## SERVICE INSTRUCTION

# Change of the gearbox configuration for ROTAX® Aircraft Engine Types 915 i A, 912 i, 912 and 914 (Series)

ATA System: 72-00-00 Engine

Fig. 1. Gearbox marking example.

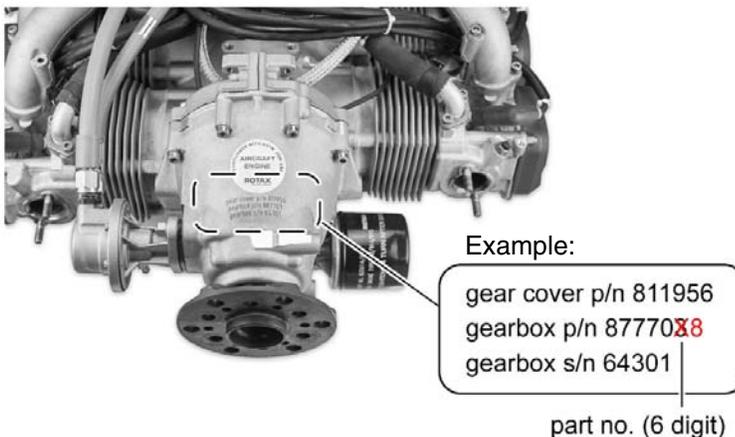
A gearbox that has been modified (e.g. change from configuration 3 to configuration 2 or vice-versa) must have its part number corrected. For correct gearbox assembly part number, refer to the current Illustrated Parts Catalog (IPC) of the respective engine type.

The gearbox must be marked to reflect the new configuration.

Step	Procedure
1	Using number and letter stamps, place an "X" through the original gearbox part number and clearly mark the new configuration assembly part number to its right.

NOTE: Do not completely obliterate the old number, it must remain legible/readable.

Fig. 2. Engine data plate example (“912 iSc Sport” shown in this figure).

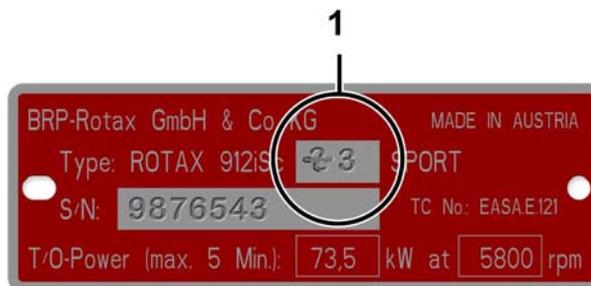
An engine that has been modified (e.g. change from configuration 3 to configuration 2 or vice-versa), must have its data plate corrected to reflect the new configuration.

**NOTE:** Do not change serial number!  
 Relevant authorities require that the old number must remain legible.  
 The engine data plate must be marked to reflect the new configuration.

Step	Procedure
2	Using number stamps, place an single “-” (strike-through or dash) on the original configuration number and clearly mark the new configuration to its right (1).
3	An engine log entry must now be made, indicating work performed, change in gearbox configuration and change to engine configuration. Log entry must include serial number of engine and gearbox.
